Draft Report

**Upper Ash Pond Dam
– A.B. Brown Station
Assessment Report**

July 2009

AB BROWN
 POWER PLANT
 UPPER EMBANKMENT
 SECTION

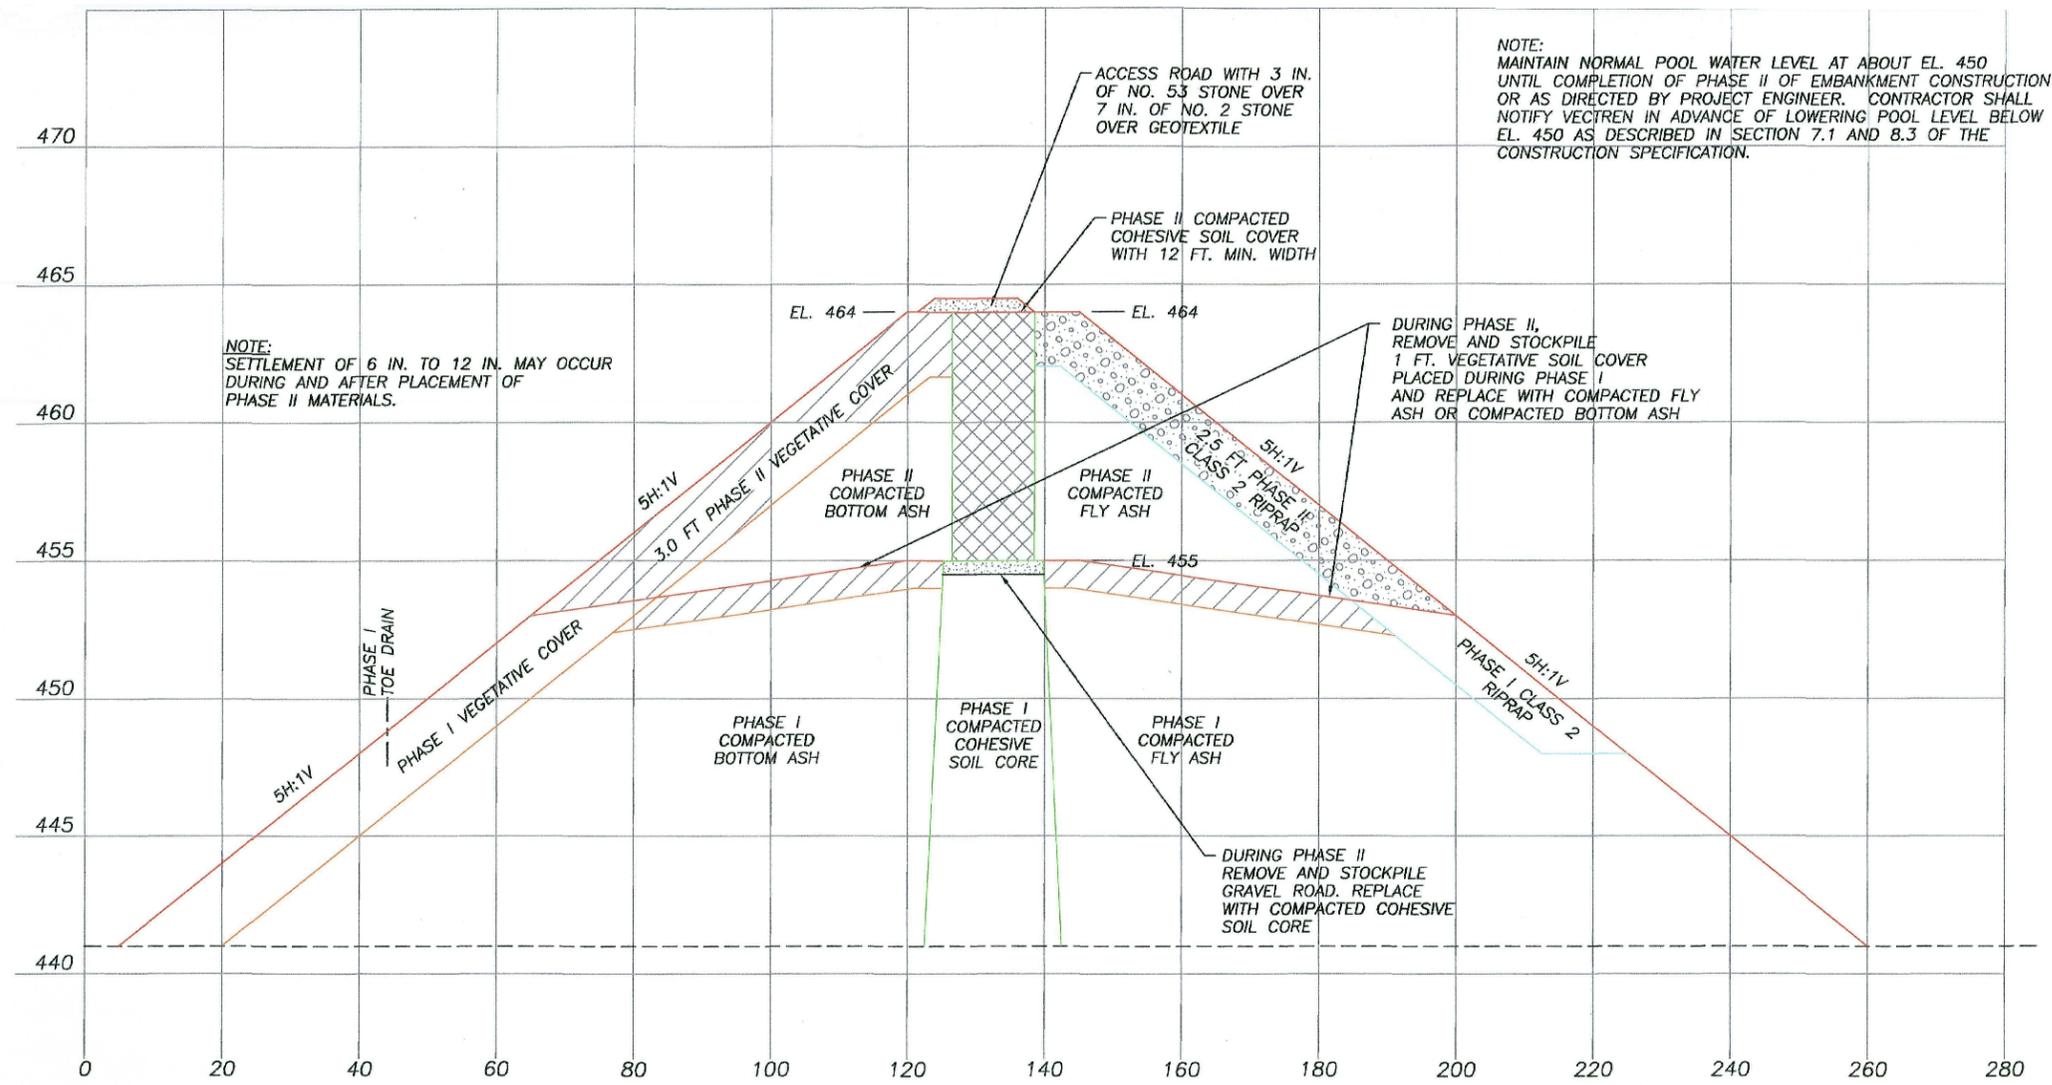
- The Upper Dam embankment design included an upstream zone of compacted fly ash, a central compacted cohesive soil core, and a downstream zone of compacted bottom ash. The embankment was placed over a foundation of uncompacted loose coal ash, with a biaxial geogrid to support the initial lifts of embankment placement. The embankment side slopes are 5H:1V, which is very flat by dam engineering standards and resulted in adequate safety factors for slope stability.

- During Phase I construction of the Upper Pond Dam, concerns were raised over the proposed fly ash zone and the design was subsequently modified to incorporate more natural soil and less fly ash.
- The 2002 Permit Application recognized that the loose saturated pond ash is susceptible to liquefaction under earthquake conditions and noted that “there is a possibility that the proposed embankment could be significantly damaged due to earthquake-induced liquefaction of the foundation soils.” However, it also noted that this condition was acceptable to the owner since a failure of the Upper Dam would not cause any significant downstream damage and due to the low probability of a seismic event during the relatively short estimated life cycle (about 15 years) for the Upper Pond.

The calculated safety factors of 2.46 for the steady state seepage condition, 1.34 for the end-of-construction case, and 1.16 for earthquake loading exceed the typical minimum allowable safety factors for these loading conditions. However, the earthquake loading condition does not account for liquefaction potential, which was discussed in Section 3.2 above.

- Although not a likely scenario, the potential for liquefaction of the foundation during seismic activity raises a dam safety concern. Consideration should be given to the development of safeguards against the consequences of foundation liquefaction.

2. The potential liquefaction issue should be investigated to establish a procedure for monitoring and/or protection against the consequences of foundation liquefaction during a seismic event. The procedure may be as simple as inspection of the earth embankment during or immediately after any measurable earthquake, but some measures should be implemented to address this issue.

Photo 14- Emergency Spillway Looking West. Note Vegetation Growth in Spillway

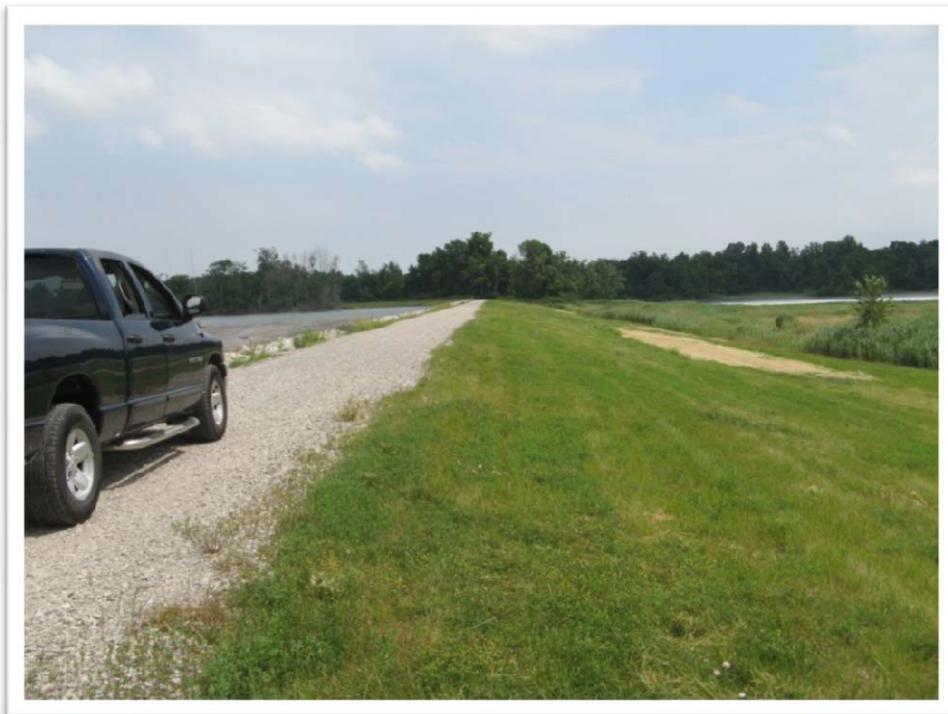
Spillway System - The principal spillway, which consists of a 60-inch diameter RCP drop inlet at El. 460 with a 24-inch diameter outlet pipe, was discharging at the time of inspection. The outlet pipe discharges into a rock-lined channel which leads to the Lower Pond. The emergency spillway is a 30-foot wide trapezoidal earth channel with 5H:1V side slopes and a crest elevation of 461.5. Both portions of the spillway system appeared to be in good condition; however, some overgrowth of vegetation was observed in the emergency spillway outlet channel.

2. Spillway System – The drop inlet principal spillway appears to be in good condition and functioning as designed. The trash rack for the drop inlet opening is somewhat smaller than typical spillway racks, but should be adequate for the limited amount of runoff experienced by the Upper Pond. The emergency spillway also appears to be in good condition, with a riprap cover that should adequately protect the outlet channel against erosion during heavy flows. Some overgrowth of vegetation is evident in the outlet channel, but should not significantly inhibit flow through the spillway.

3. The vegetation in the emergency spillway outlet channel should be removed to prevent further overgrowth and possible future blockage of the outflow path.
